ADDENDUM NO. 2

**Restroom Facility Rehabilitation
Allison-Jukebox Center-3rd Street Park
And
Building Trades Park**

ISSUE DATE: September 23, 2016

ITEM NO. 2: Several minor revisions and details have been made or added to the drawings for both facility locations. The drawings are filed under a folder titled REVISED DRAWING SHEETS. Only plan sheets with revisions are provided and are noted with the letter "R".

AD101R

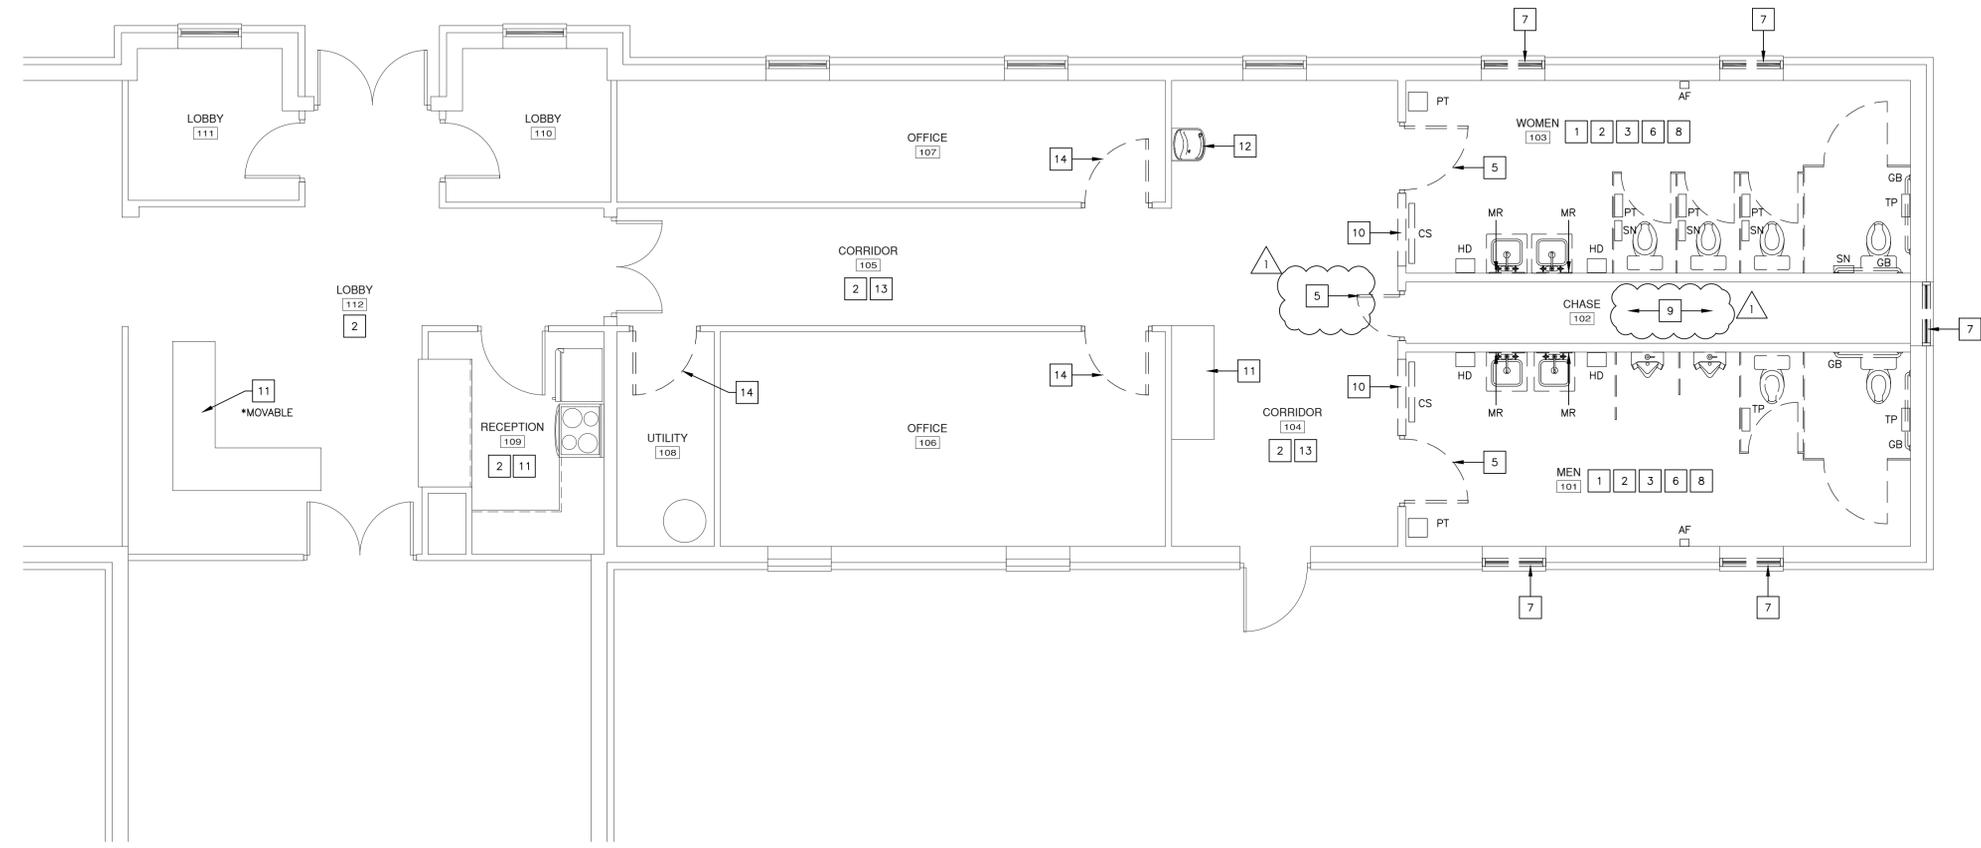
Q: Allison-Jukebox Center: In the JukeBox restroom...sheet AD101 – note 4 says to remove cabinets....there are no cabinets on the drawings. Can you tell us the cabinets to remove?

Q: Allison-Jukebox Center: *The plumbing demo says to remove waste line....where do we stop with that removal?*

A: The note has been removed from the revised drawings. There are no cabinets to be removed. Sheet AD101 has been revised.

A: Plumbing demo is to remove from the fixture to an extent to what falls within the plumbing chase room area. Plan sheet AD101, Note 9, has been revised.

- 7 REMOVE EXISTING WINDOW.
 - 8 REMOVE & DISPOSE OF EXISTING FRP WALL PANELING.
 - 9 REMOVE AND DISPOSE OF ALL EXISTING PLUMBING SUPPLY LINES AND WASTE LINES INCLUDING CAST IRON HUBS, SUPPORTS AND VALVES. REMOVAL LIMITS SHALL BE FROM FIXTURE TO A POINT THAT EXITS THE PLUMBING CHASE. THIS AREA IS ON A CRAWL SPACE.

AE101R

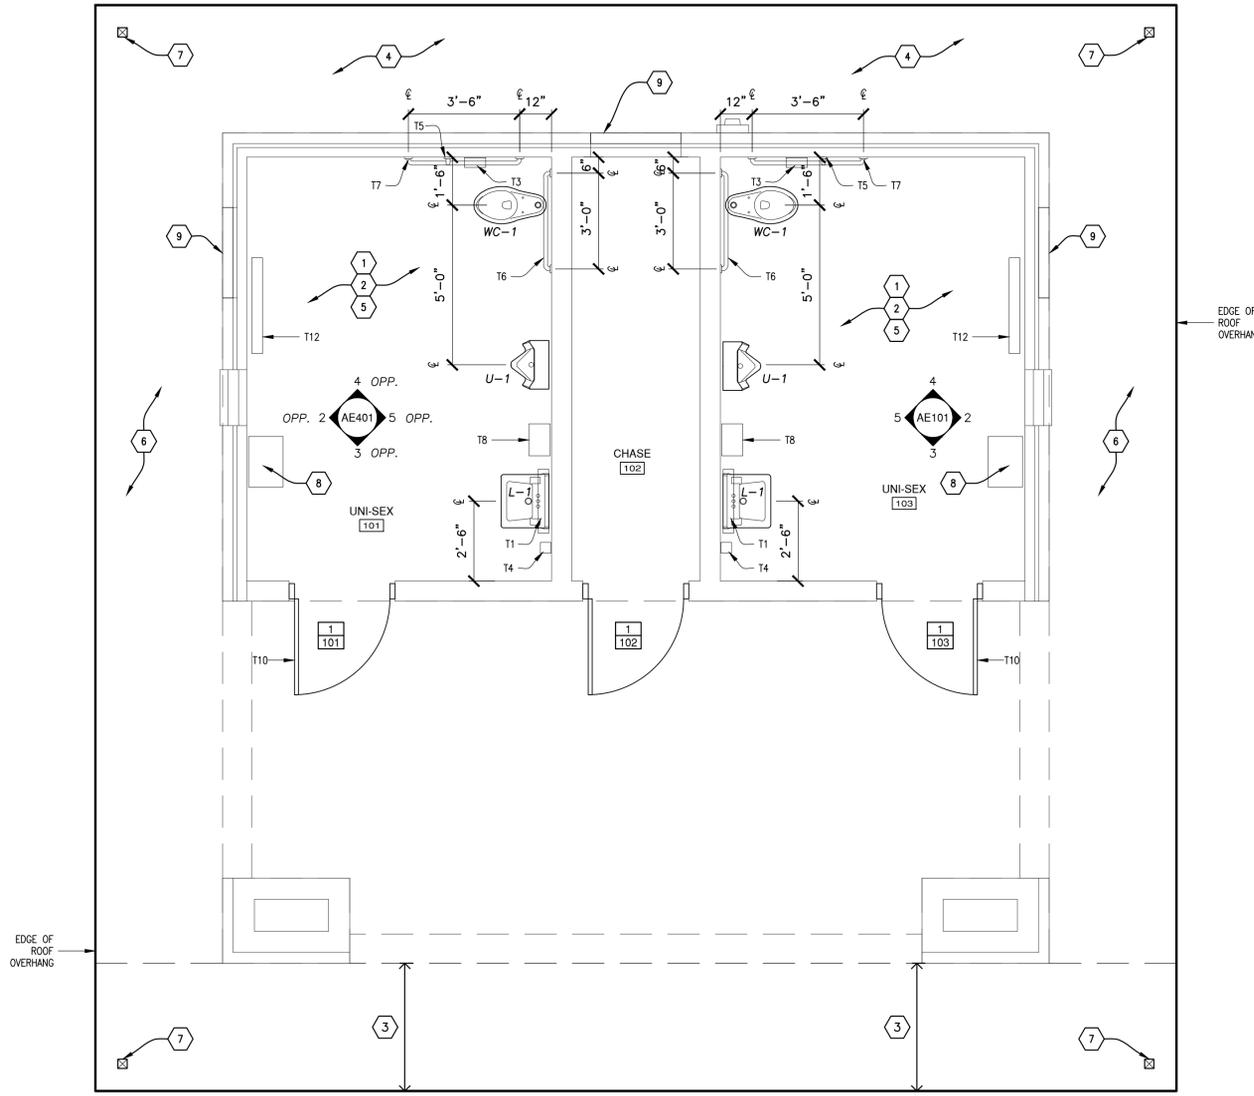
Q: Building Trades Park: (Sheet) AE101 says to prepare walls smooth for paint....but the walls are block. Do we skim coat the block to make smooth?

Q: Building Trades Park/ Allison-Jukebox Center: We are assuming no floor finish in bathroom....is that correct?

A: No skim coat. Provide specified paint and primer and paint surfaces as is.

A: The floor finish for Building Trades Park shall be cleaned, sealed concrete. Revisions have been made to the plans and specifications. The Allison-Jukebox Center floor finish requires new vinyl composition tile (VCT). See Sheet AE601.

- 1 ALL CONC. BLOCK WALLS TO BE PAINTED W/ PRIMER AND PAINT AS SPECIFIED. NO SKIM COAT NEEDED.
- 2 ALL CEILINGS TO RECEIVE FRP OVER EXISTING PLYWOOD (SEE FINISH SCHEDULE).
- 3 NEW POURED 6" CONC. SLAB OVER MIN. 4" CRUSHED STONE. PROVIDE #5 DOWELS INTO EXISTING SLAB @ 4'-0" O.C.
- 4 EXISTING CONC. SLAB TO REMAIN.
- 5 CLEAN EXISTING EXPOSED CONCRETE FLOOR SLAB W/ POWER WASHING AND DETERGENT. SEAL W/ SOY SEAL.
- 6 PAINT ALL EXISTING WOOD SOFFIT. REATTACH WHERE LOOSE.
- 7 PROVIDE TREATED 4X4 WD. POST W/ STAND OFF BASE TO SUPPORT EXISTING ROOF JOIST. NOTCH AS REQUIRED + BOLT THRU 2X FRAMING W/ MIN. 1/2" GALV. BOLT.
- 8 EXISTING S.S. TRASH RECEPTACLE TO BE REINSTALLED.

SHEET NO.
AE101R

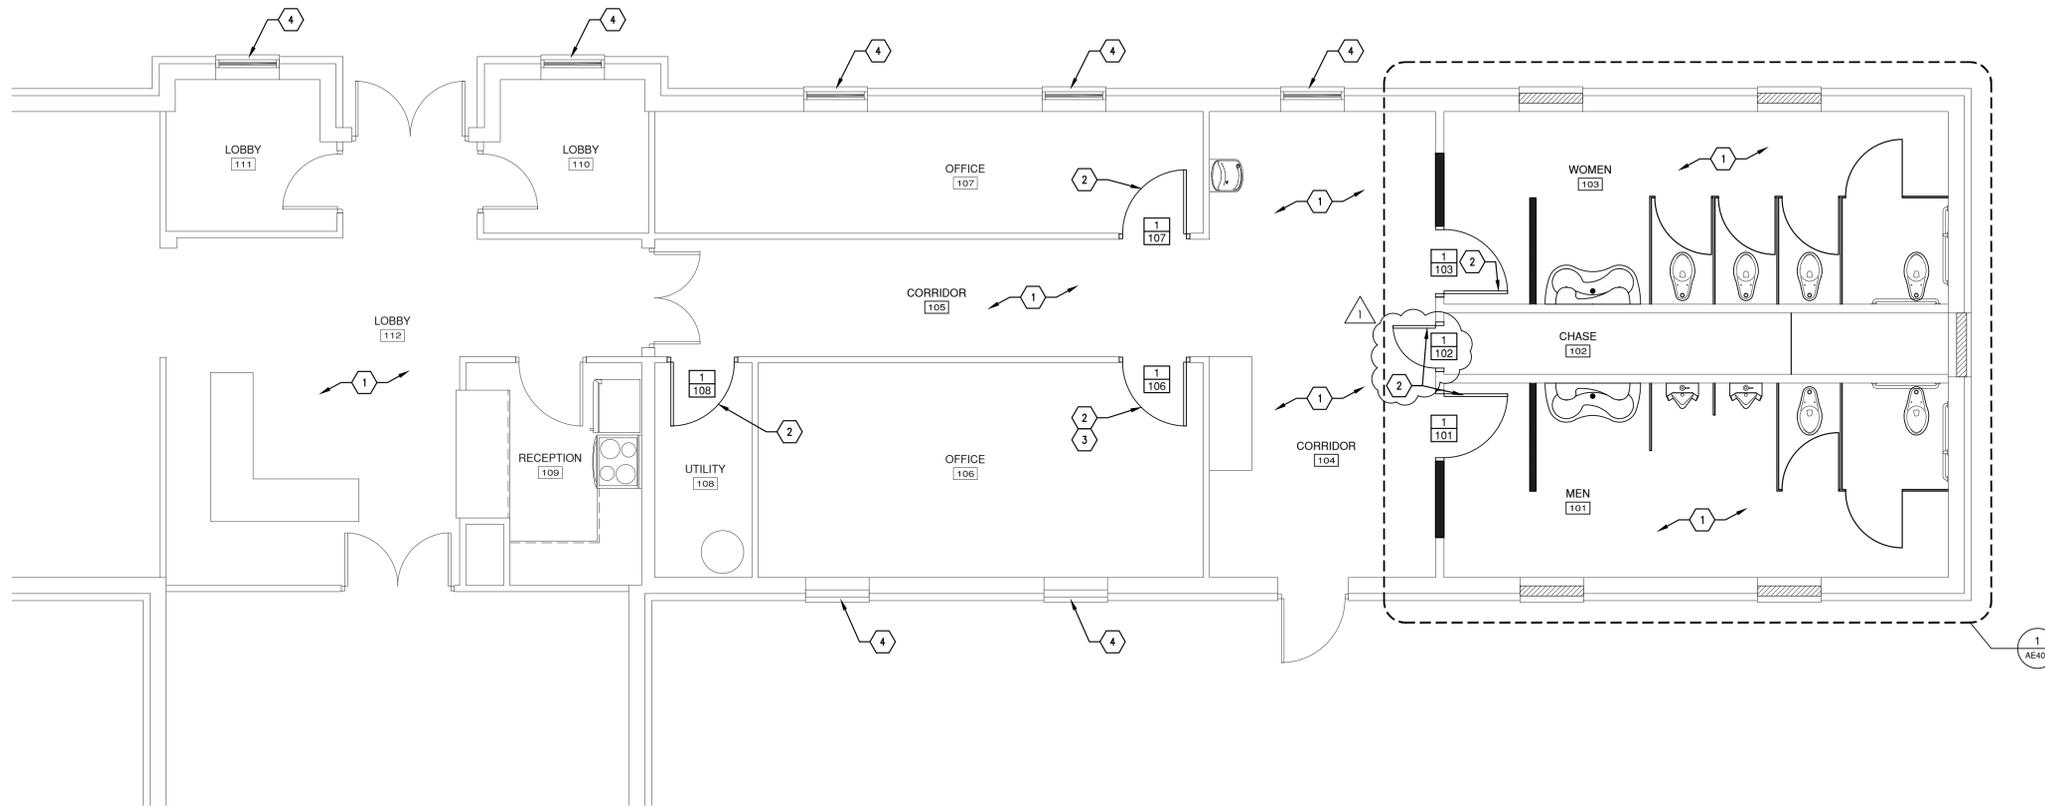
Q: Allison-Jukebox Center: AE 101 door 1/102....do we replace that door? It doesn't match the door schedule.

A: The pipe chaise door is to be replaced in the Base Bid. The plan sheets covering demolition details and replacement door schedule have been revised.

AE601R

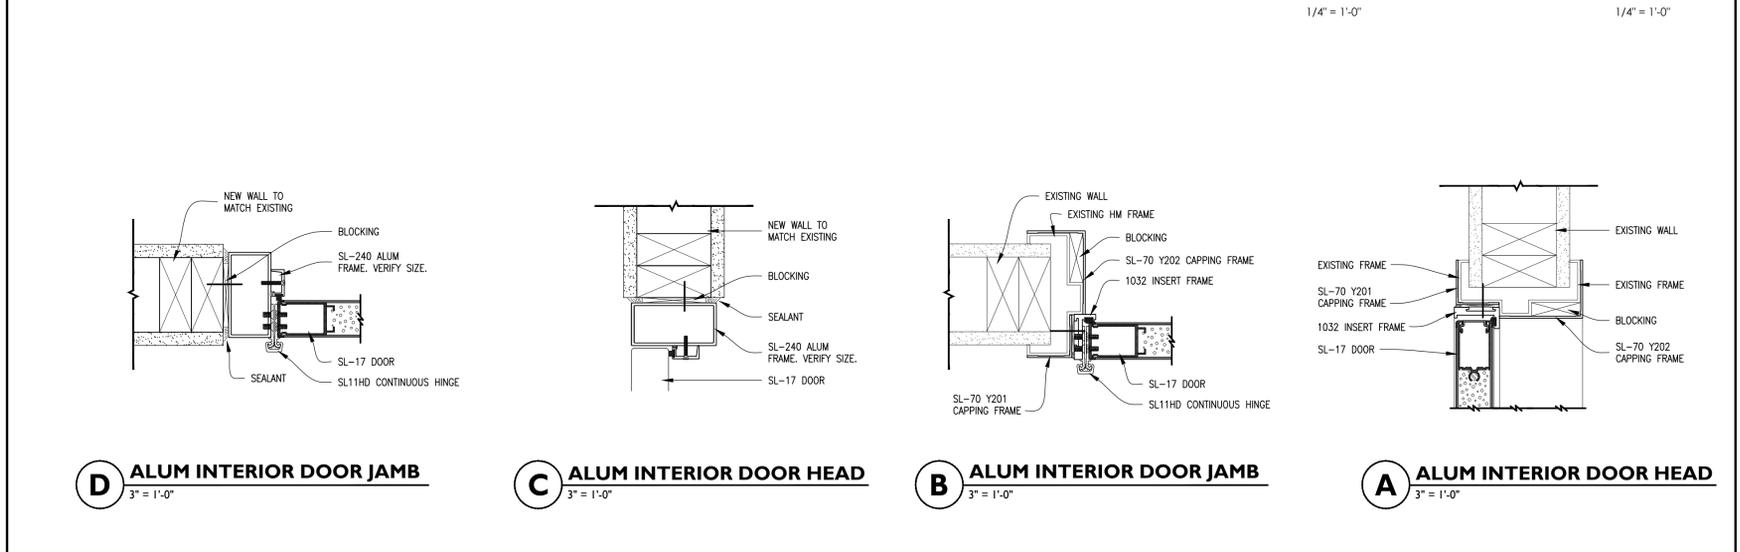
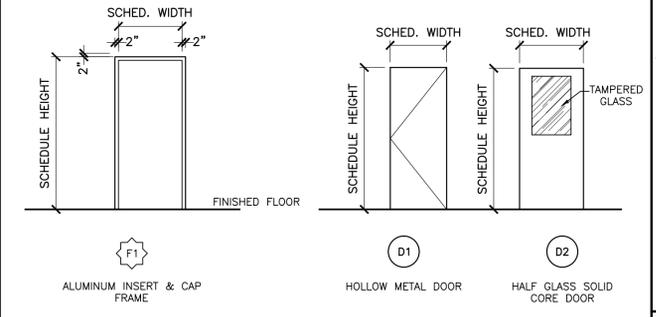
Q: Allison-Jukebox Center: We are assuming no floor finish in bathroom....is that correct?

Q: Allison-Jukebox Center: *AE 601...details call out aluminum door frames, but door schedule says hollow metal. Which is correct?*

A: Provide VCT flooring as specified on Sheet AE601.

A: The restroom doors and plumbing chase door are aluminum frame with FRP doors. The hallway doors are how metal frames with solid core wood doors. Plan sheet AE601 has been revised.
